**Comments on Other Submissions
(submitted at Deadline 2)
for the
Royal Society for the Protection of Birds
and Suffolk Wildlife Trust**

**Submitted for Deadline 3
24 June 2021**

**Application by NNB Generation Company (SZC) Limited for an Order
Granting Development Consent for
The Sizewell C Project**

**Planning Inspectorate Ref: EN010012
RSPB Registration Identification Ref: 20026628
Suffolk Wildlife Trust Registration Identification Ref: 20026359**

Figure 3-1 - Sea Defence Layout

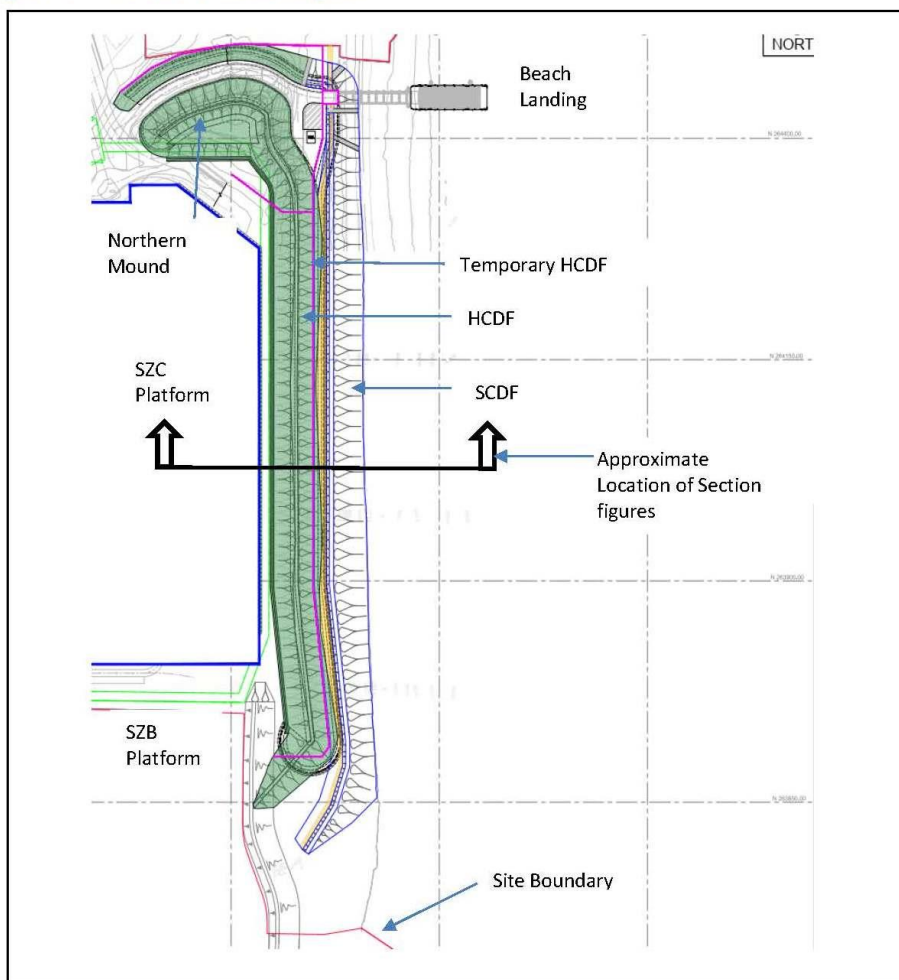
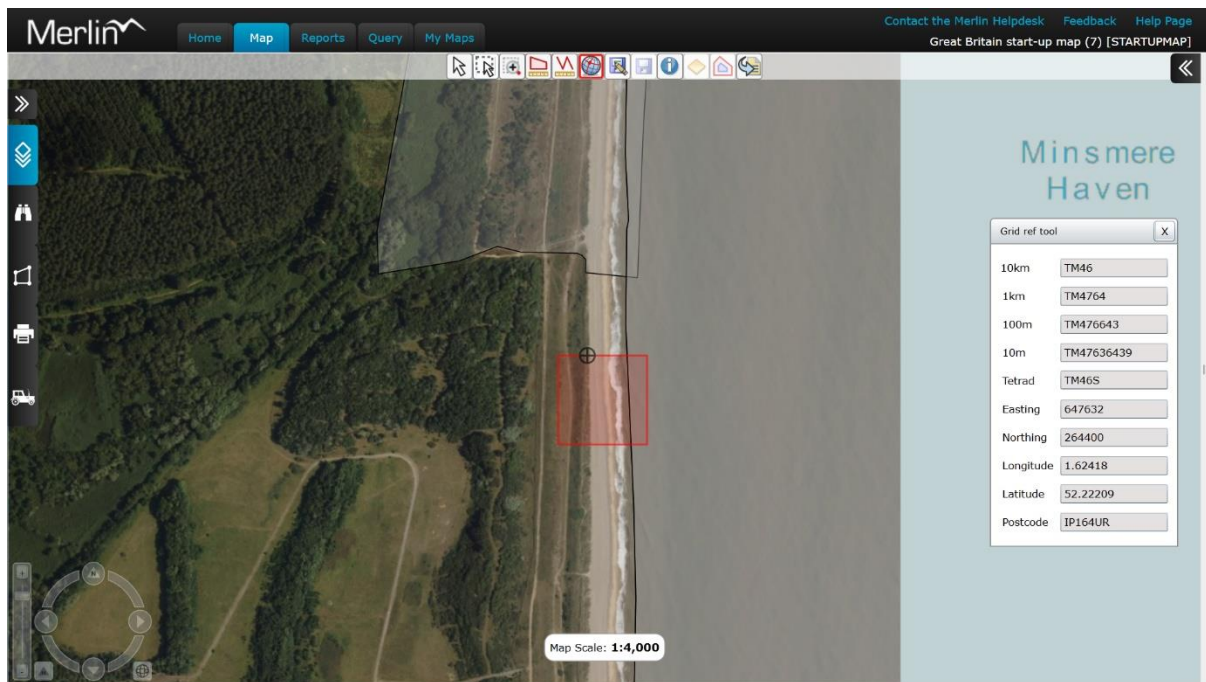
- 6.1. Below we set out our comments in relation to this Report ⁵².
- 6.2. Although paragraph 3.3.4 on page 9 indicates *the design considers a number of constraints and interfaces, including: ...temporary BLF*, we cannot locate further reference to the presence of the temporary BLF in the document and remain concerned that this has not been given full consideration.
- 6.3. The designs provided still appear to represent indicative drawings rather than detailed plans which can be related to features on the ground. We have sought to compare Figure 3-13 (page 7) (repeated below as Figure x) with an aerial photograph (Figure y, below) and locate the

position of the Temporary HCDF at the base of the permanent BLF from the position indicated by the northing and eastings provided. This would indicate that the seaward edge of the Temporary HCDF at this point lies along the seaward edge of the dune. The 'dune' at this point forms part of the current defences for the site and it also provides the boundary with the shingle beach which is designated as a County Wildlife Site for its plant communities.

- 6.8. Figure 3-2 (page 8) shows a boundary fence in the cross section to exclude the public from the temporary HCDF. The applicant appears to have allowed no land for this boundary fence beyond the Temporary HCDF on the boundary of Minsmere at the northern edge along the red line. Again we question how the Applicant intend to manage this interface without access to RSPB land?

- 6.9. The route of the path for the public (demarcated in yellow on Figure 3-1 (page 8)) is blocked by the temporary HCDF at the base of the permanent BLF. It is indicated that there will be measures put in place to re-direct people onto the beach either side of this feature. We have concerns regarding this approach outlined below. Re-directing visitors onto the beach who are walking
